City of Franklin

Franklin Municipal Planning Commission

Thursday, September 26, 2019

CAROTHERS GLEN PUD SUBDIVISION, REZONING
ORDINANCE 2019-34
FRANKLIN MUNICIPAL PLANNING COMMISSION
9/26/2019

9. Sanitary sewer

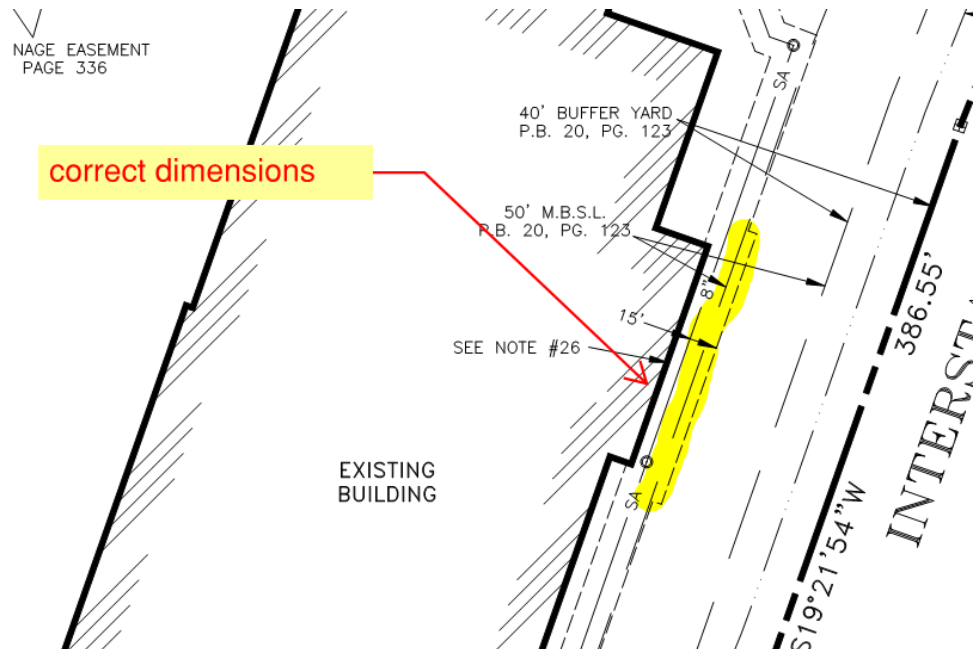
ben.mcneil@franklintn.gov The applicant has corrected the majority of the issue. The applicant shall clear up the lines shown below to ensure there is no confusion with the future sewer easements.

25. Sanitary sewer

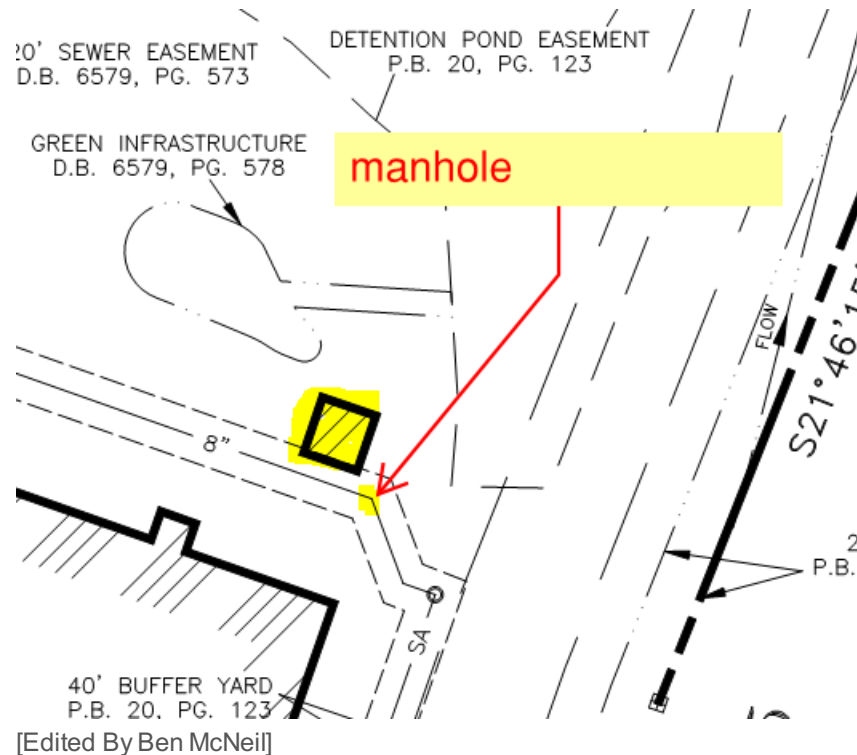
ben.mcneil@franklin.tn.gov With the latest submittal of the plat, the sanitary sewer alignment has changed. The applicant shall clarify the square shown below and ensure the square is not in the easement. If the square is a structure, additional easement shall be granted and noted that the City of Franklin is not responsible for structure during maintenance or replacement of sewer.

26. Sanitary sewer

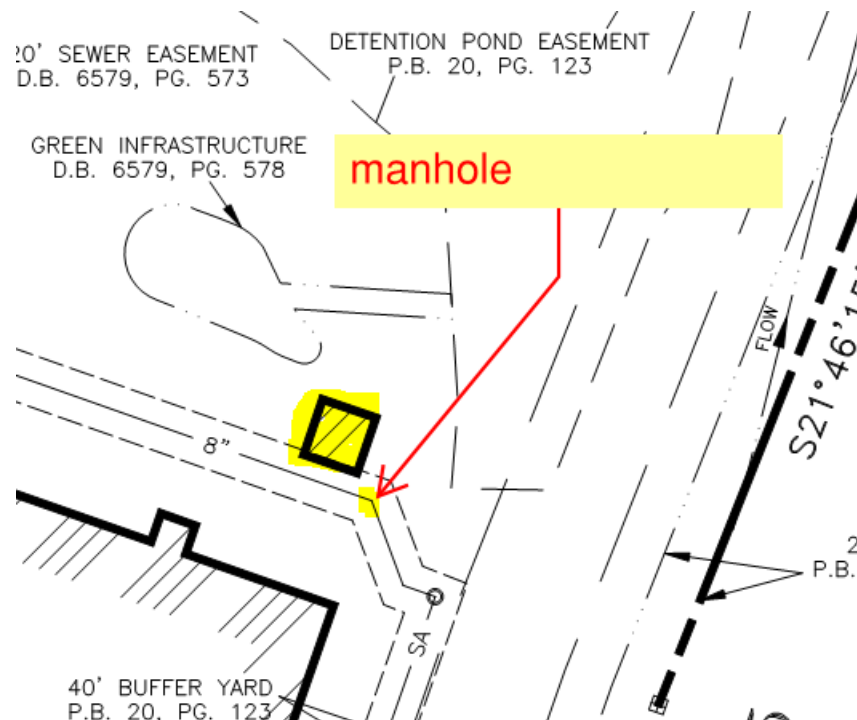
ben.mcneil@franklin.tn.gov The applicant shall show the manhole on the existing sanitary sewer main below. The new alignment has left the manhole off.

63. C. Final Plat

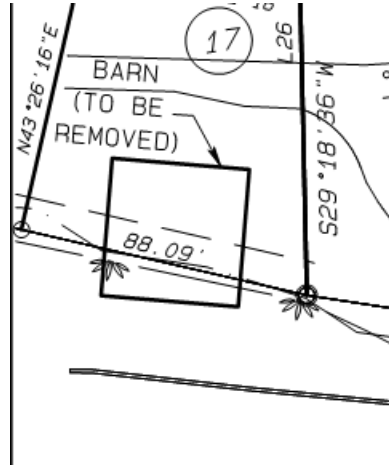
lance.fittro@franklin.tn.gov Applicant shall clarify whether the existing barn shown on the previous submittal as "to be removed" has now been removed, or is still existing:

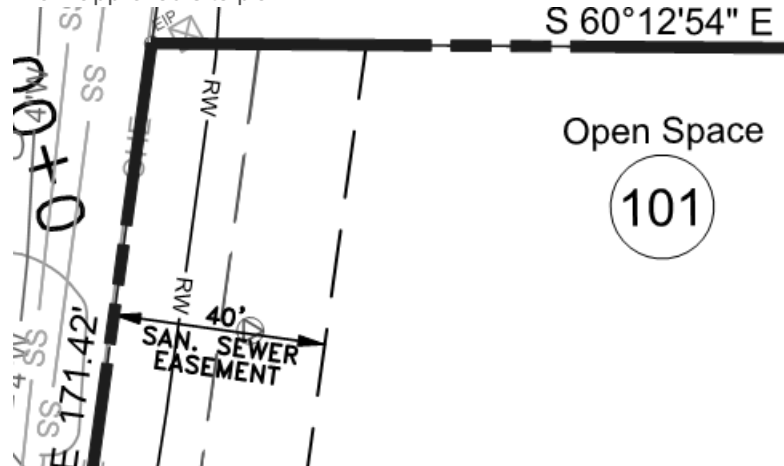
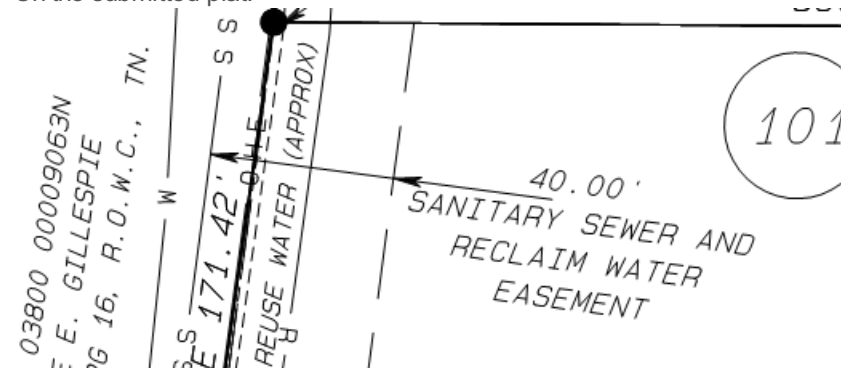
For the 40' Sanitary Sewer and Reclaim Water Easement shown below, applicant shall indicate the easement line as offset 40' from the property line, as it was depicted on the approved Site Plan, rather than 40' from the sewer line as shown on the plat:

71. Site Plan Amendment

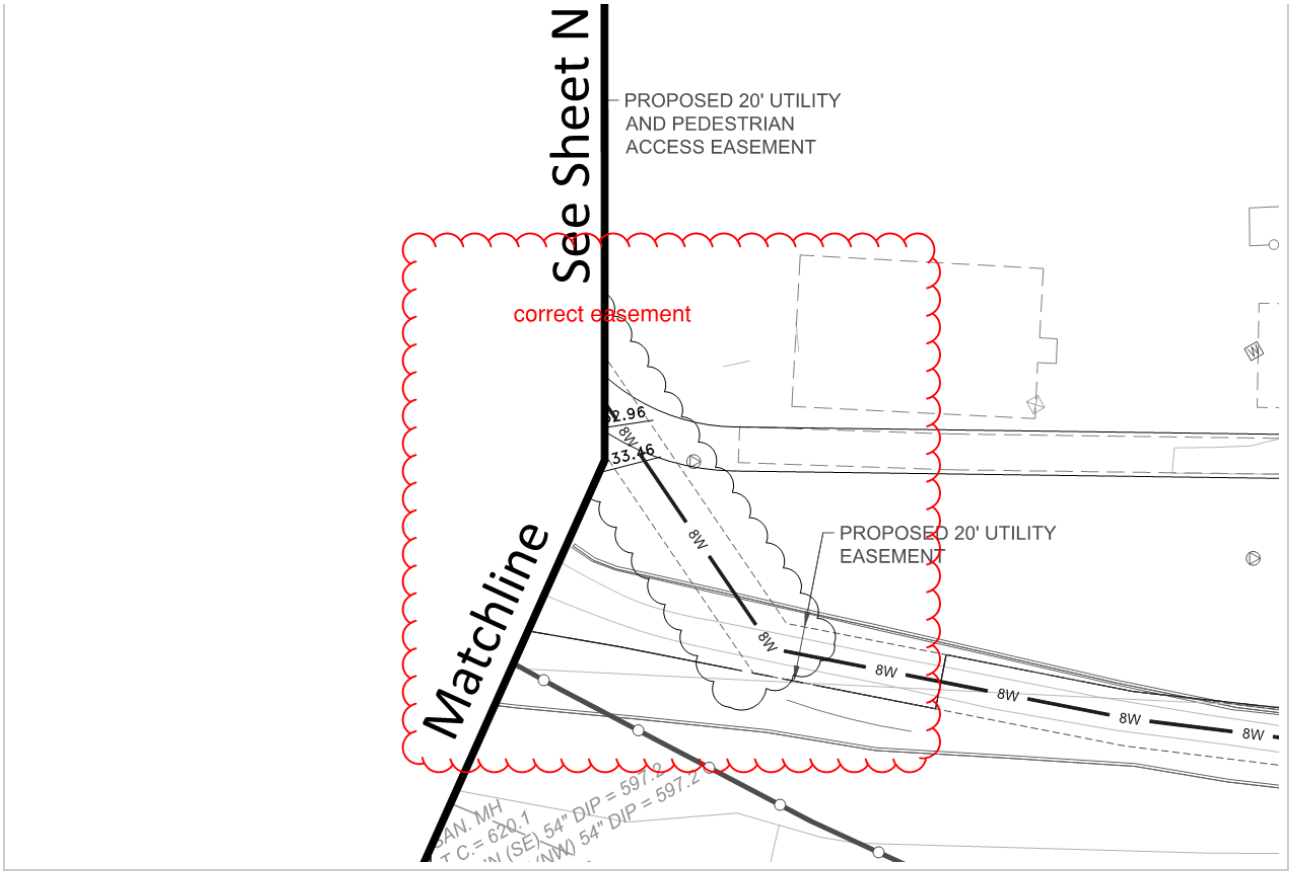
joseph.bryan@franklintn.gov Comment to remain open as a condition of approval. A site plan amendment will be required to match the lots on plat with the site plan. The final plat cannot be approved at one-stop until the site plan amendment has been reviewed and approved.
